Number	Description
1	Revised Table of Contents; Add NTB Nos. 3704, & 6691; Amendment EBS Download Required.

**MISSISSIPPI DEPARTMENT OF TRANSPORTATION
TABLE OF CONTENTS**

PROJECT: NHPP-0002-06(022)/107209301 - Lee

SECTION 904 - NOTICE TO BIDDERS NO. 3704

PROJECT NUMBER	PCU-2
SHEET NUMBER	
FILE NAME	00033.RCP.CS1.S5.2.GD01
DESIGN TEAM	
DATE	12/14/18

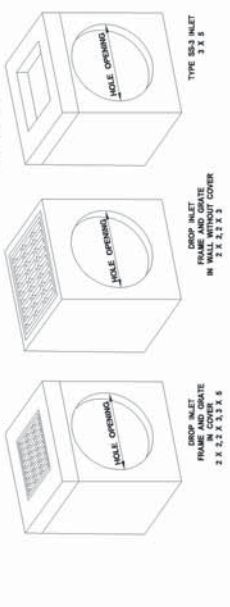
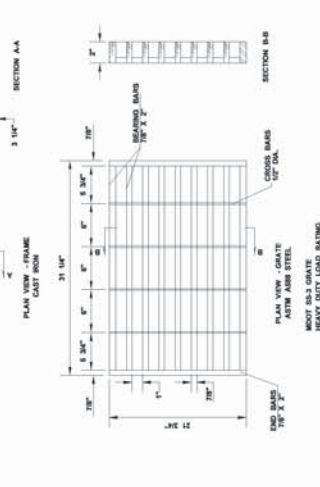
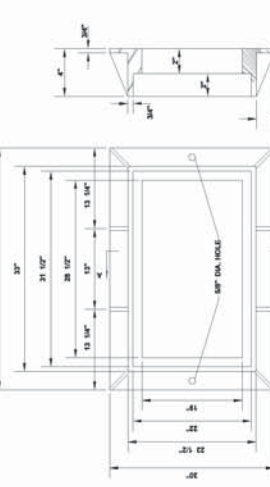
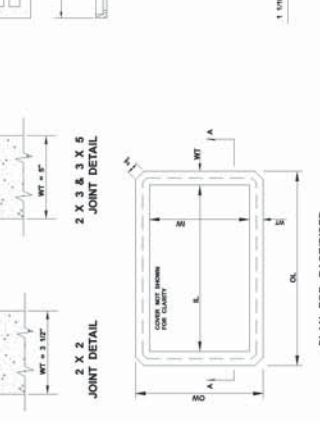
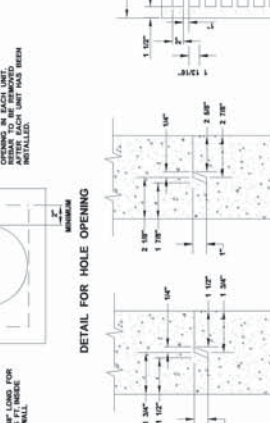
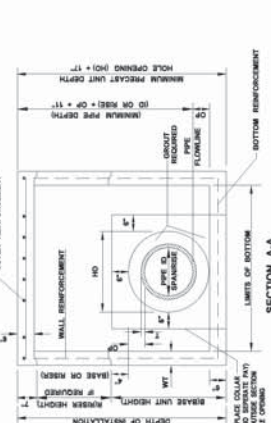
Bidders attention is brought to the content of Subsection 601.02.3 regarding precast units. MDOT Drawing Sheet Nos. PCU-1 and PCU-2 address MDOT approved precast drainage units. The Contractor must make a request to the Project Engineer for approval to use precast units other than the ones shown on Drawing Sheet No. PCU-1 or PCU-2.

Bidders are advised that precast drainage unit tops are only allowed on units shown on Drawing Sheet No. PCU-1. Cast-In-Place drainage unit tops are required on units shown on Drawing Sheet No. PCU-2.
